REMARKS

VERSION WITH MARKINGS TO SHOW CHANGES MADE

FIG. 2A

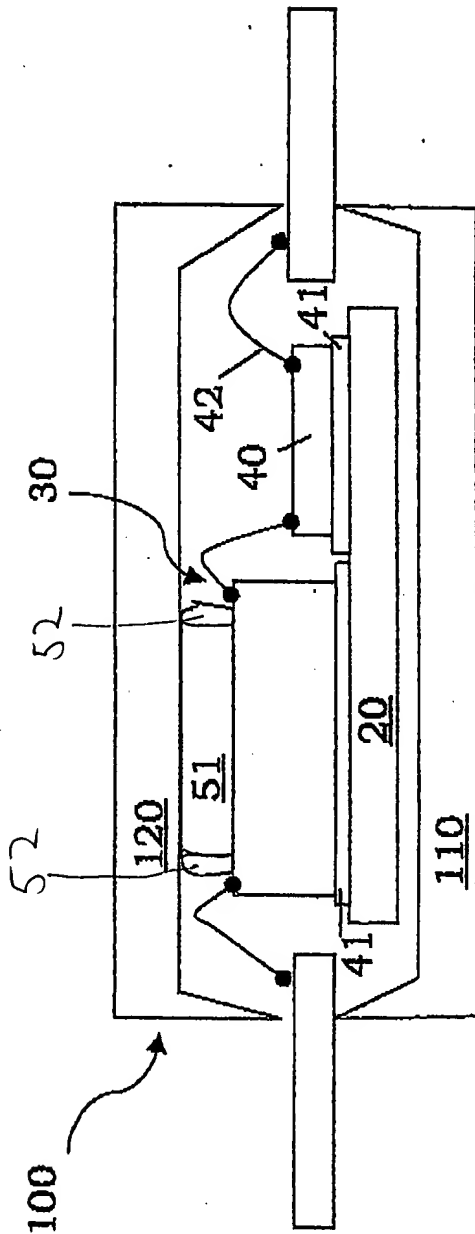
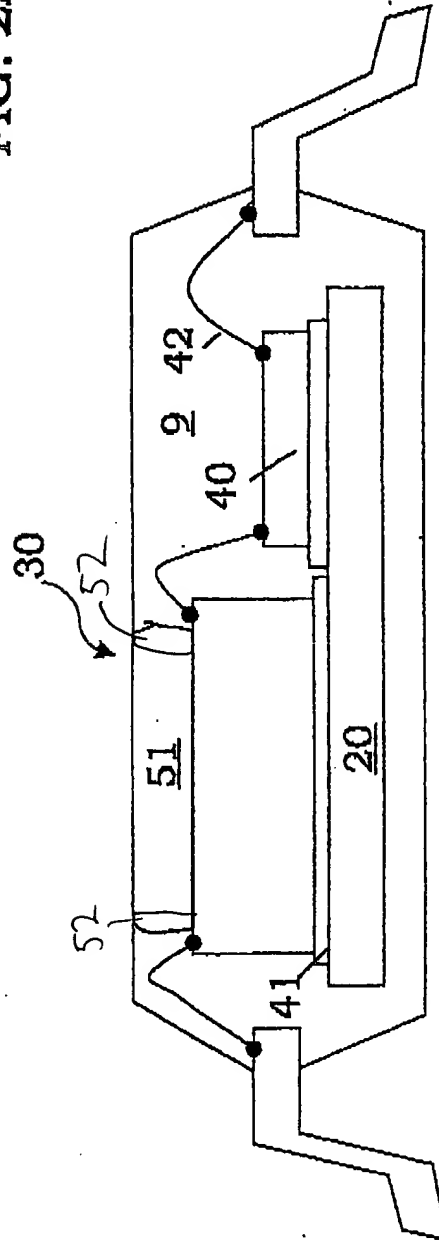
The drawings were objected to as failing to show the “dyke or barrier” of claims 22-23. Being filed herewith is a request for drawing change showing a dyke or barrier 52 in Figures 2A, 2B in accordance with claim 22 and the original specification. Claim 23 is being canceled.

Advantageously, a ring 52 is provided on the cap of the sensor 30, which is formed out of semiconductor material, for example. This ring (~~not shown~~)52 is filled with the covering layer 50 material. Thus, the ring 52 will form a barrier or containing dyke for the covering layer 50.
